MEMORANDUM

RE: **West New Ulm – Fort Ridgely 115/69 kV Rebuild Project**
MPUC Docket No. E002/TL-08-956

**Re: Northern States Power Company
Application to Public Utilities Commission for a Route Permit West New
Ulm – Fort Ridgely 115/69 kV Rebuild Project**

MPUC Docket No. E002 /TL-08-956

General Vicinity Map
Revised Appendix B.1

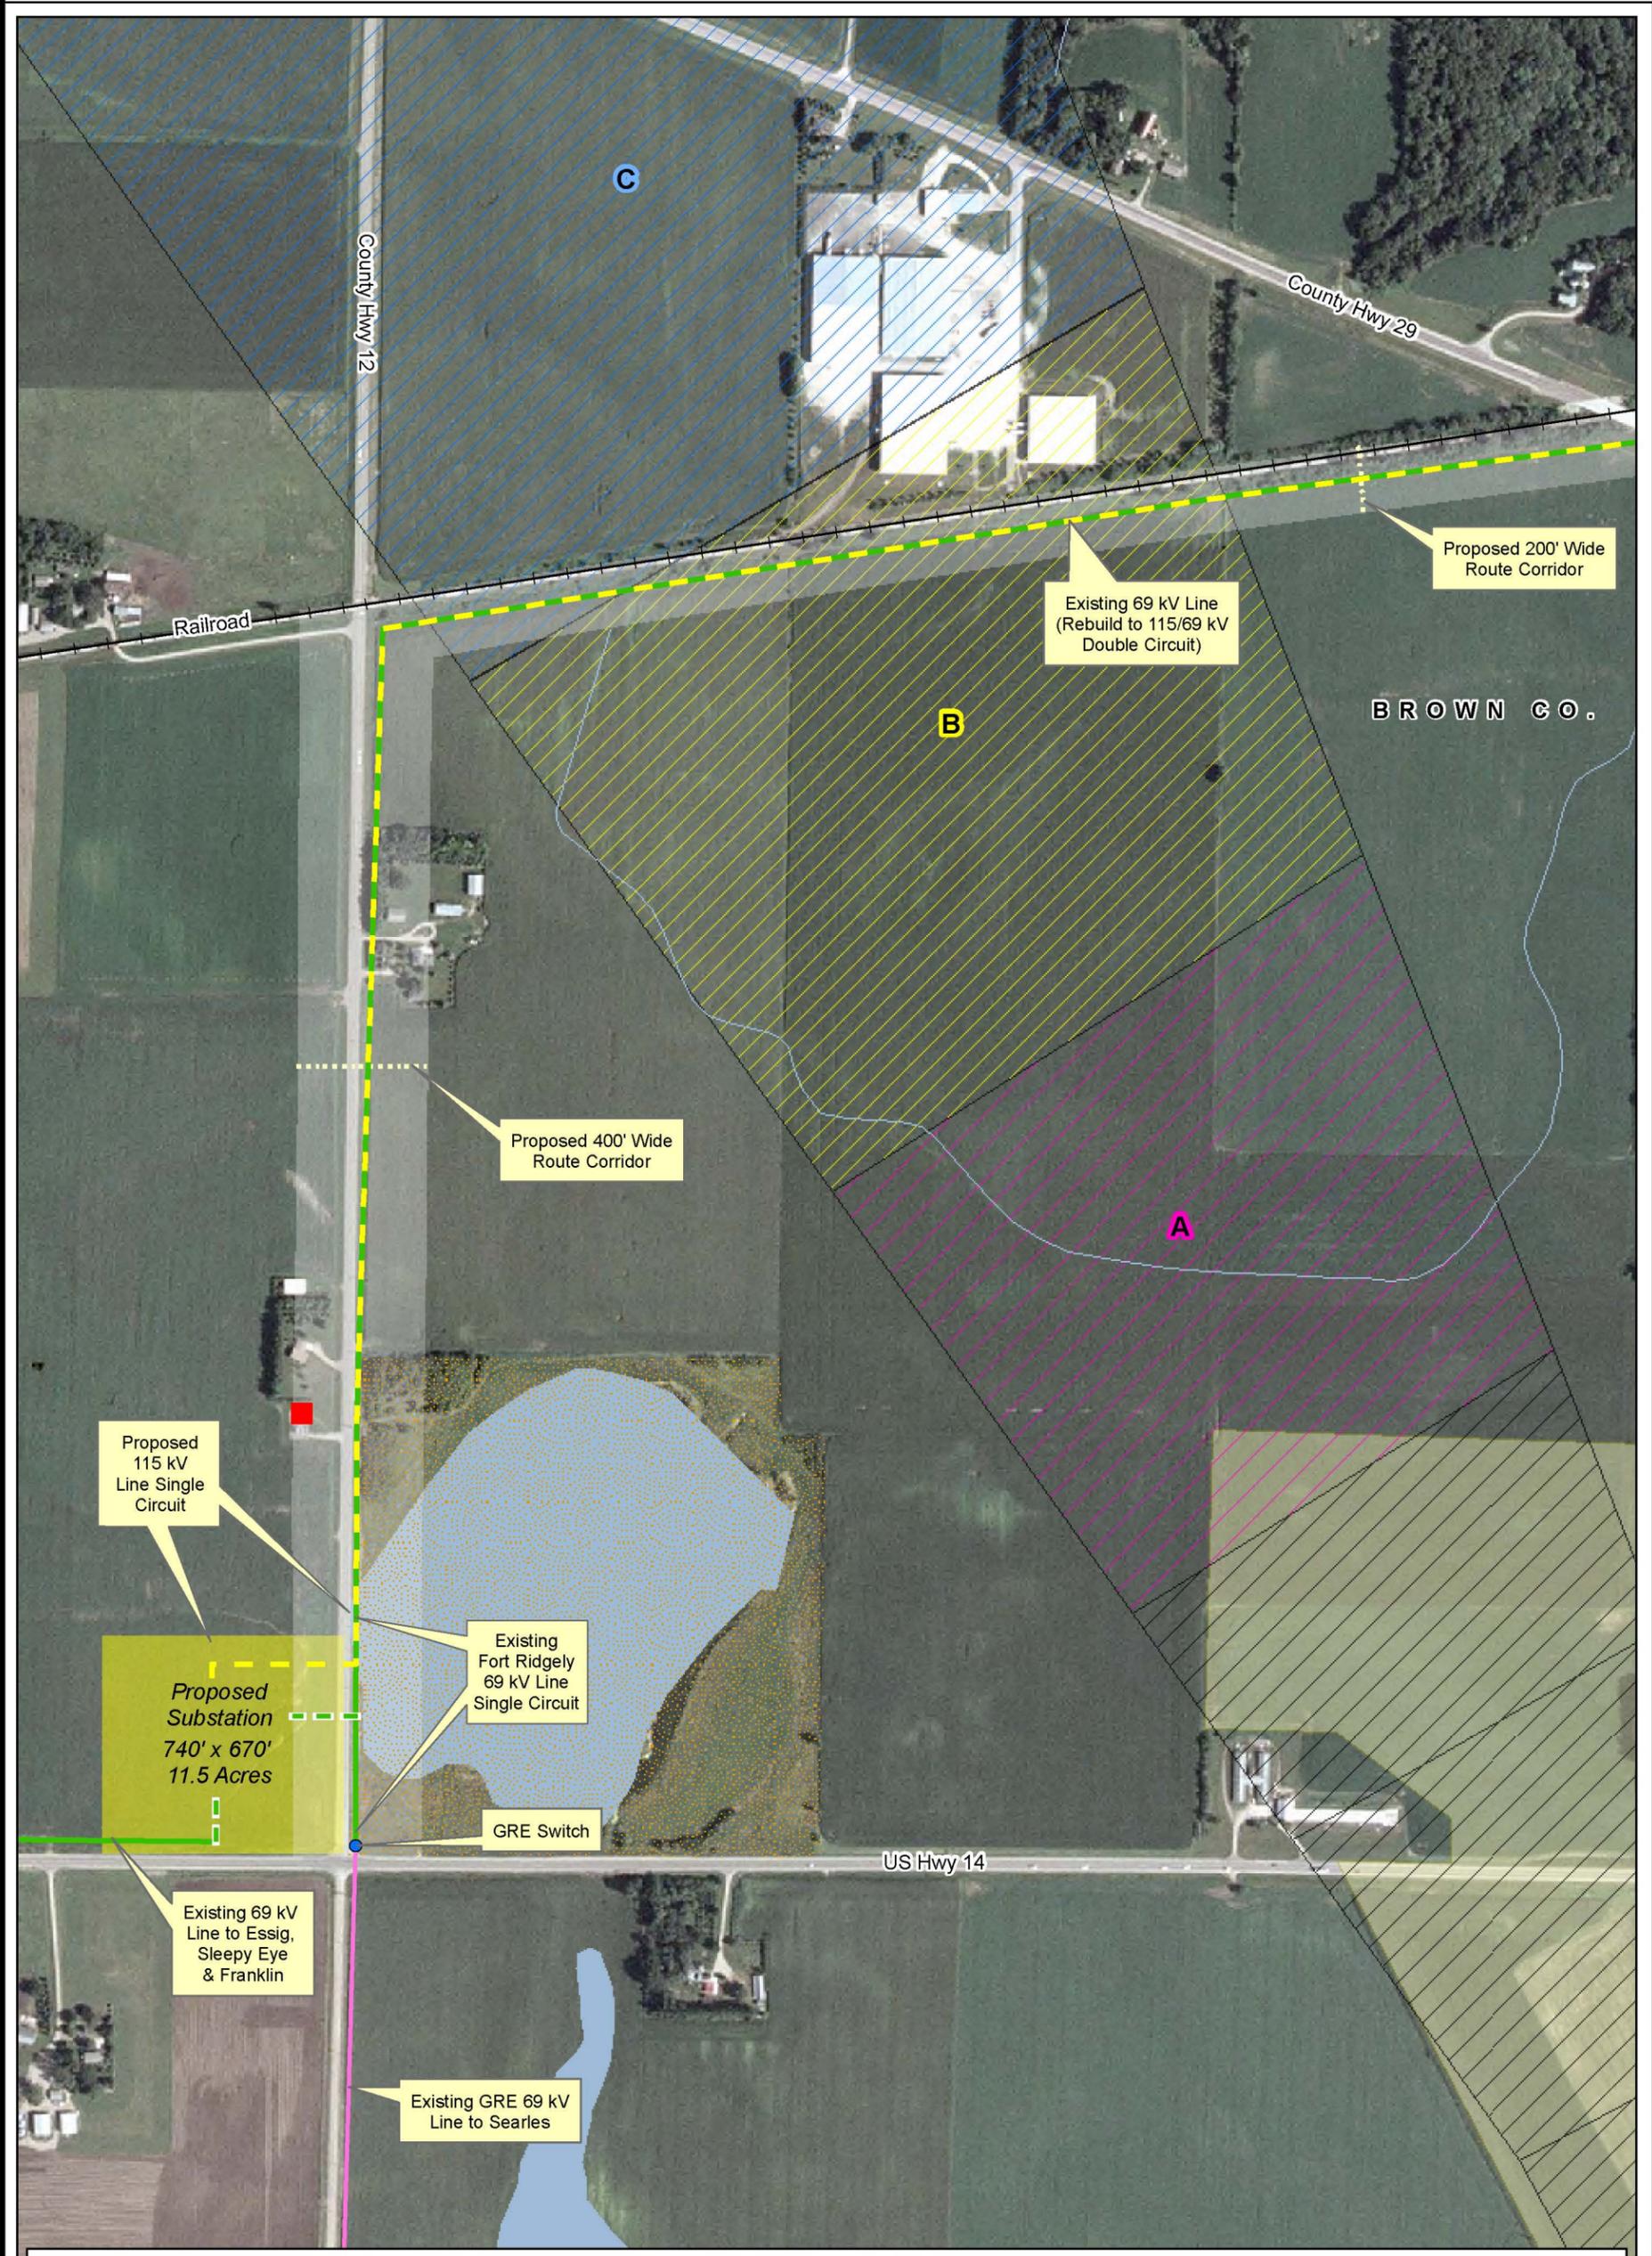
- Figure B.1: This figure was revised to correctly show the location of the 115 kV line when it splits from the 69 kV line and crosses County Highway 12 into the West New Ulm Substation. For this segment, the line will be within the substation fence, not outside the fence as shown.
- Figures B.2a, B.3 and B4: The same change noted above regarding the 115 kV line was made to all three diagrams. In addition, the green and yellow dashed lines along County Highway 12 representing the proposed 115/69 kV double circuit transmission line were consolidated into one line. Figure B.2a was also revised to show a route width of 400 feet (200 feet on each side) along County Highway 12 as opposed to 800 feet (400 feet on each side) to match the text of the Application.

Project Location Map
Revised Appendix B.2a

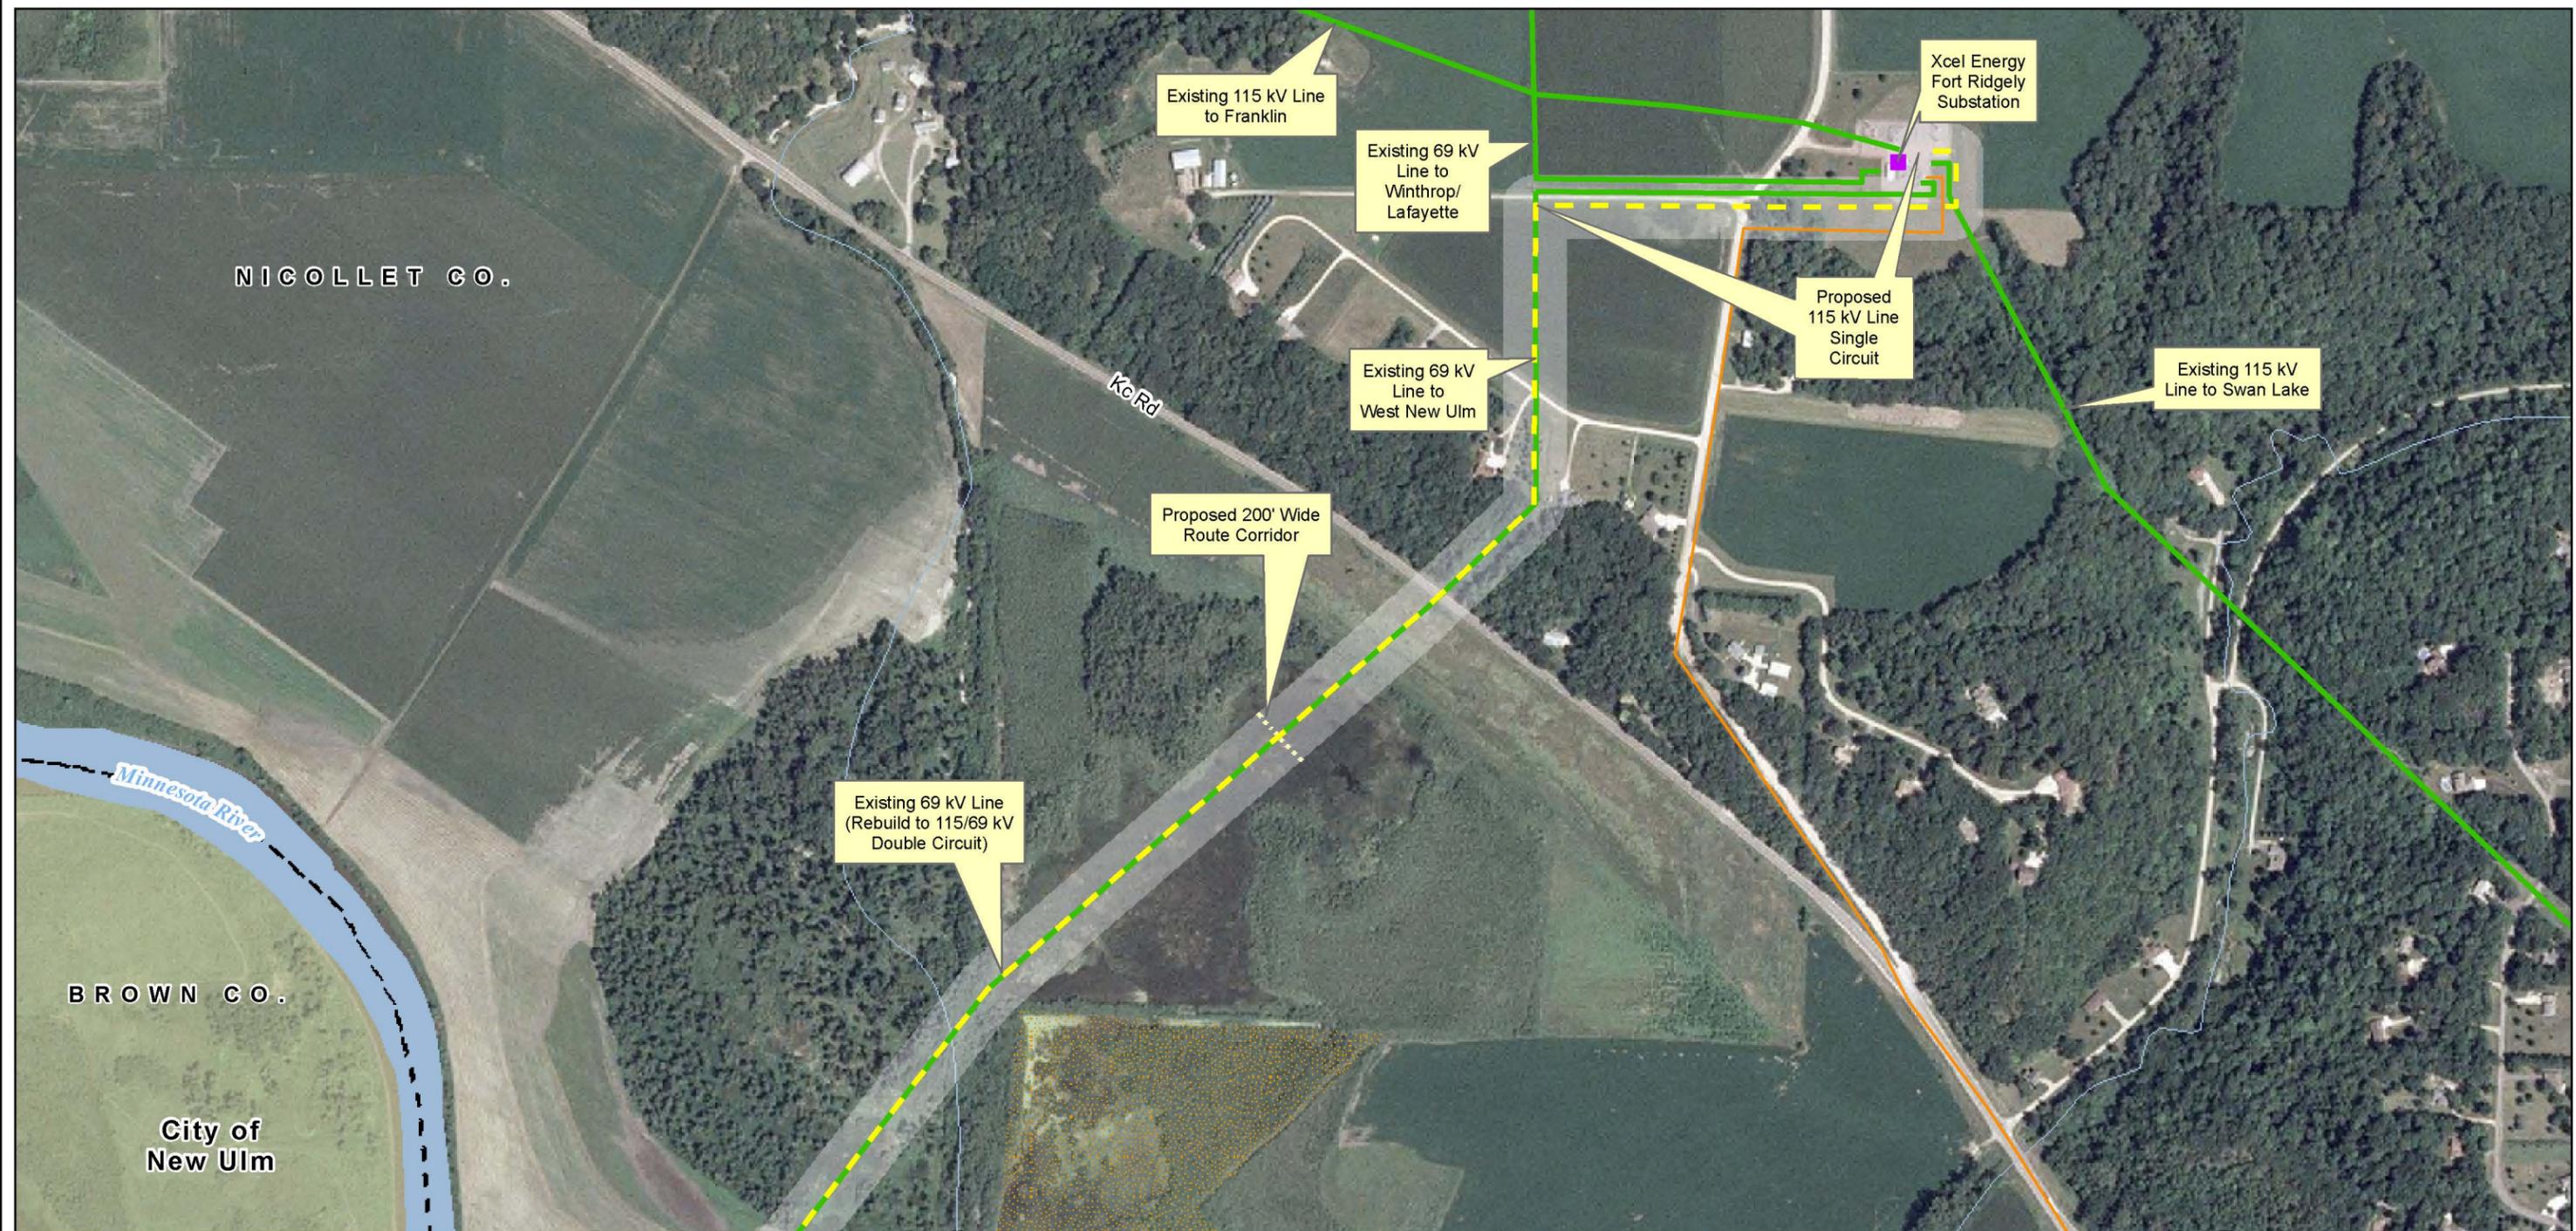
(1) You noted that Figure B.2a depicts a route width of 800 feet (400 feet on each side) while the text of the Application states that the requested route width is 400 feet wide (200 feet on each side of the centerline). The text in the Application on page 4, 2nd paragraph, is correct. Attached is a revised Figure B.2a that shows the correct total requested route width of 400 feet.

(2) Your email also asks about the route width for the portion of the proposed 115 kV line once this line splits from the existing 69 kV line near the proposed West New Ulm Substation. As shown in the revised Figure B.2a, once the 115 kV line splits from the 69 kV line and crosses County Road 12, the 115 kV line will be within the West New Ulm substation fence line. As a result, there is no requested route width for this portion of the line. Figure B.2a incorrectly showed the line to be located outside the substation area. This error has been corrected on the enclosed revised Figure B.2a.

West New Ulm Substation Plan View
 Revised Appendix B.5

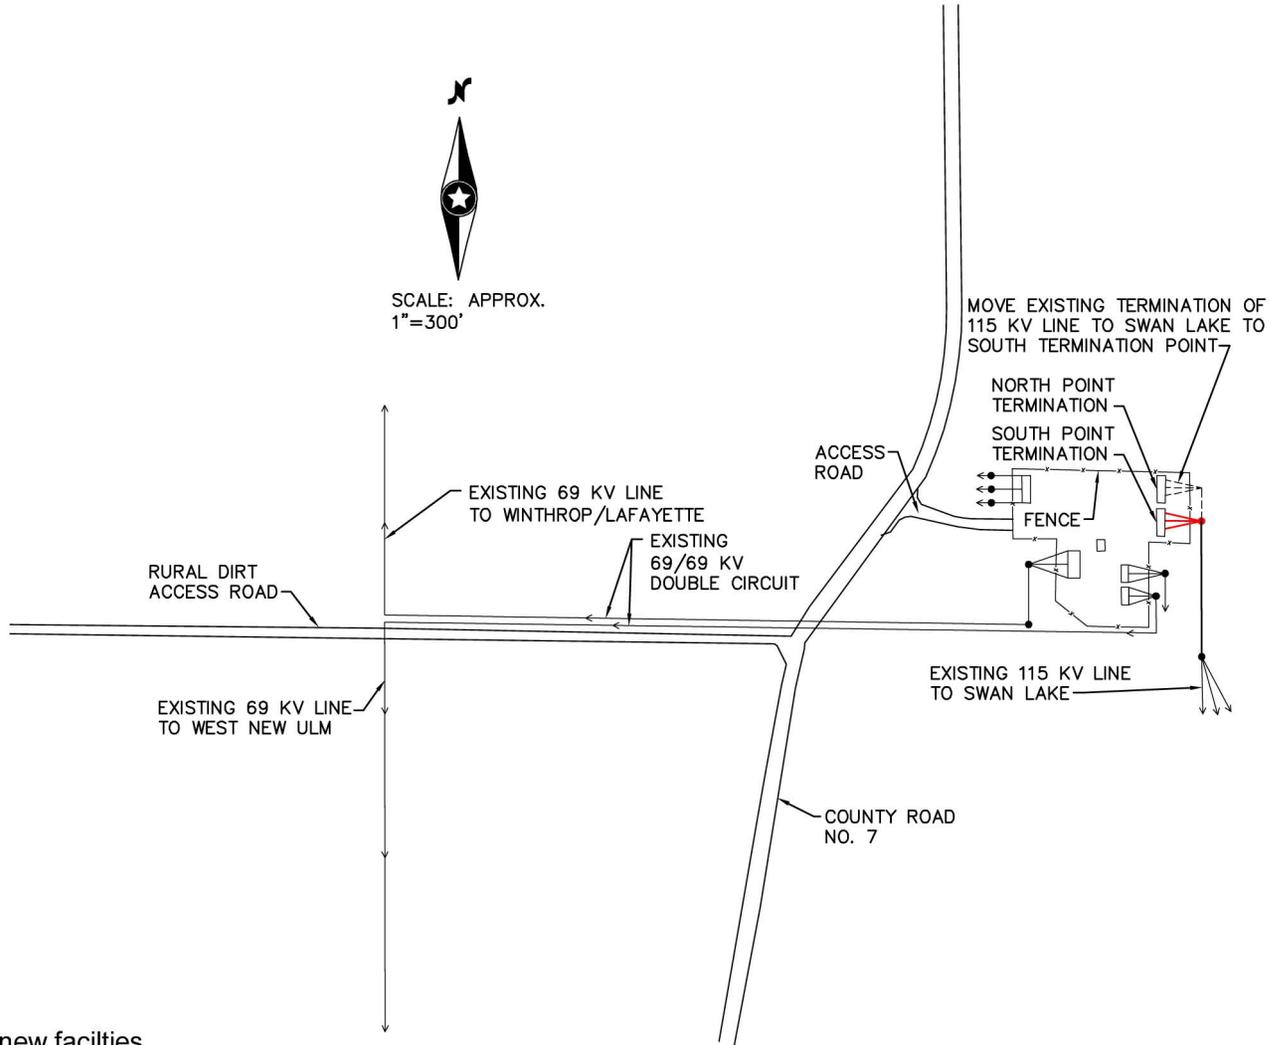
(4) The final question in your email concerns Figure B.5 and the location of that portion of the proposed 115 kV line from Fort Ridgely into the West New Ulm Substation near County Road 12 as shown on Figure B.5. Figure B.5 is a substation electrical diagram and does not represent the actual placement of the transmission lines. While the diagram appears to show two separate lines north of the West New Ulm Substation, the 115 kV line and the 69 kV line will actually be located on double circuit structures north of the substation as depicted in the revised Figure B.2a. The 115 kV line will only become single circuit once it turns west across County Highway 12 into the West New Ulm Substation.

- Figure B.2c: The labeling of one of the transmission lines was changed from New Ulm Public Utilities to Xcel Energy to represent the correct owner.
- Figure B.5: This figure was revised to show the 115 kV line on the same structure as the 69 kV line east of County Highway 12.
- Figures B.6a and B.6b: These figures were revised to correct the labeling of the lines coming into and out of the Fort Ridgely Substation.
